Raff for Lyman

RECEIVED
 TOWN OF CANANDAIGUA
 DEVELOPMENT OFFICE
 AUG 21 2020
 FOR REVIEW

Figure 5.30
Reinforced Silt Fence

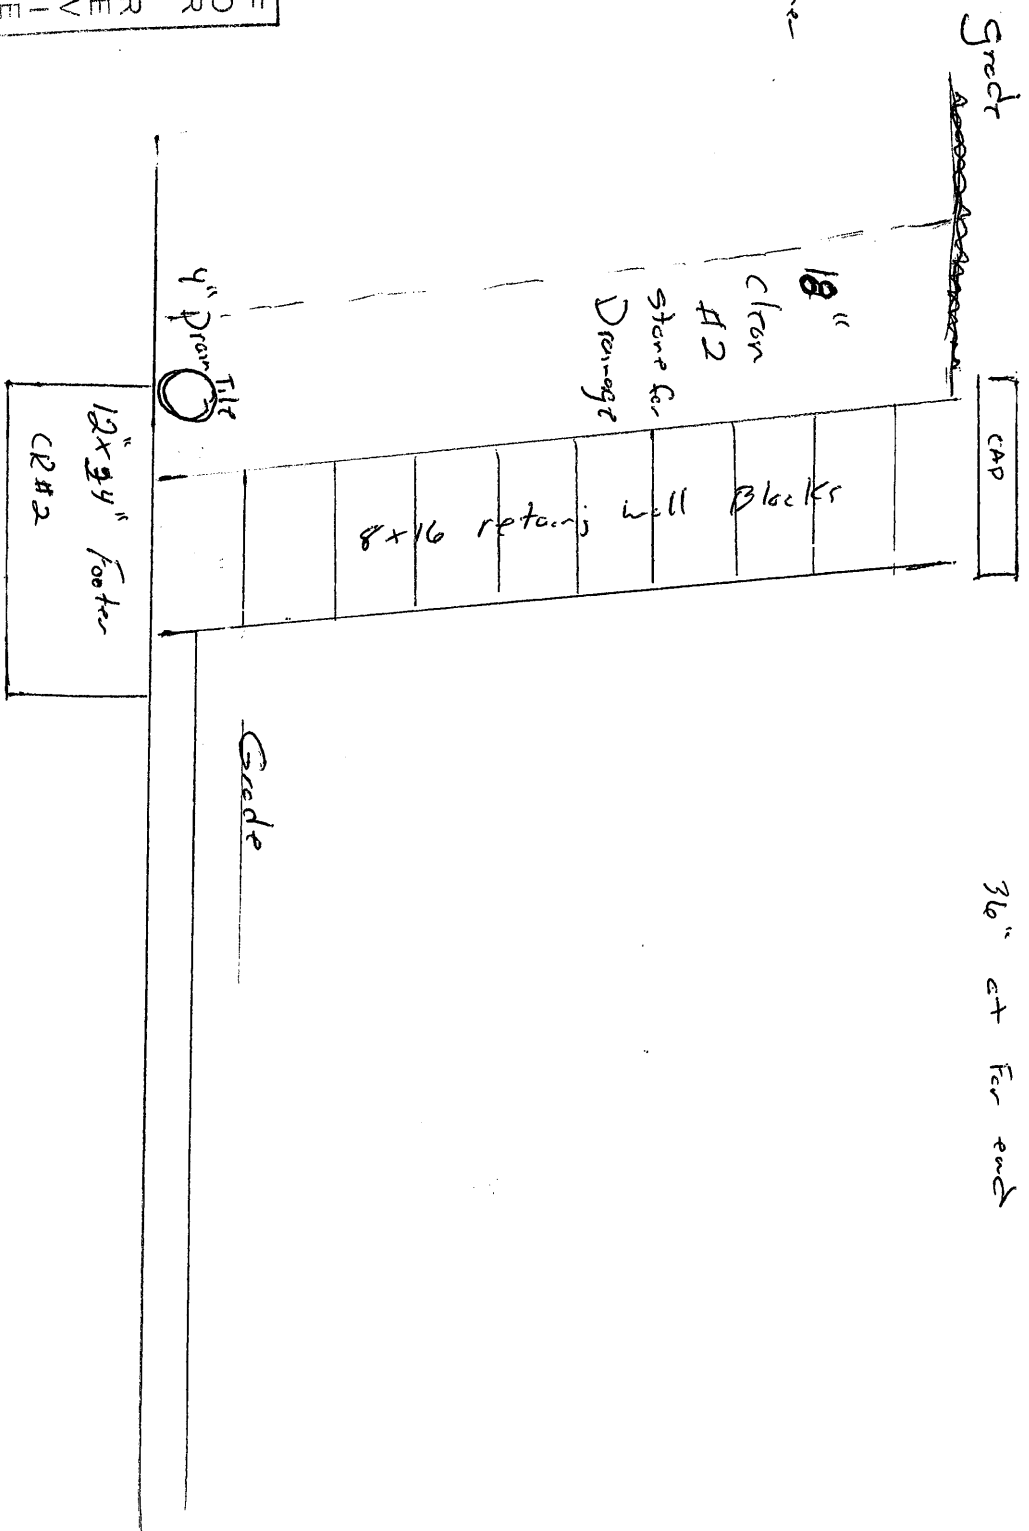
3 = Silt fence Buried 8" with Joint overlapped
4', Buried fence compacted
